Technical Service Bulletin (TSB)
Noise From Steering Wheel While Turning

REFERENCE:	TSB: 08-251-24 REV. A GROUP: 08 - Electrical	Date:	December 12, 2024	REVISION:	08-251-24
VEHICLES AFFECTED:	<p>2023 - **2025** (B1) Jeep Renegade 2023 - **2025** (H1) Jeep Commander 2023 - **2025** (M1) Jeep Compass This bulletin applies to vehicles built on or after **July 24, 2023 (MDH 07248XX)** and on or before November 14, 2024 (MDH 1114XX).</p>	MARKET APPLICABILITY:			
CUSTOMER SYMPTOM:	<p>Customers may comment on the following:</p> <ul style="list-style-type: none"> Noise when turning the steering wheel. 				
CAUSE:	Wire harness interference

Fig. 1
Steering Wheel Harness

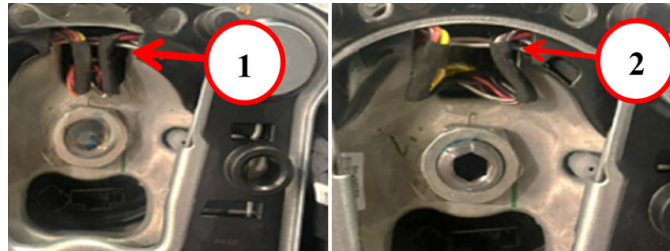
1 - Incorrectly Positioned Wire Harness
2 - Correctly Positioned Wire Harness

1. Turn the steering wheel full stop to the left and right five times.
2. Is a noise heard coming from the steering wheel when turning?
 - YES>>> Proceed to [Step 3](#).
 - NO>>> This bulletin has been completed. Use Inspection LOP (08-19-27-92) to close the active RSU.
3. Disconnect and isolate the negative battery cable.
4. Remove the Driver Air Bag (DAB). Refer to the detailed service procedures available in DealerCONNECT/Service Library under: Service Info> 4110A11 - Volante - remocao/recolocacao para versoes com air bag.
5. Correct the position of the wire harness [Fig. 1](#).
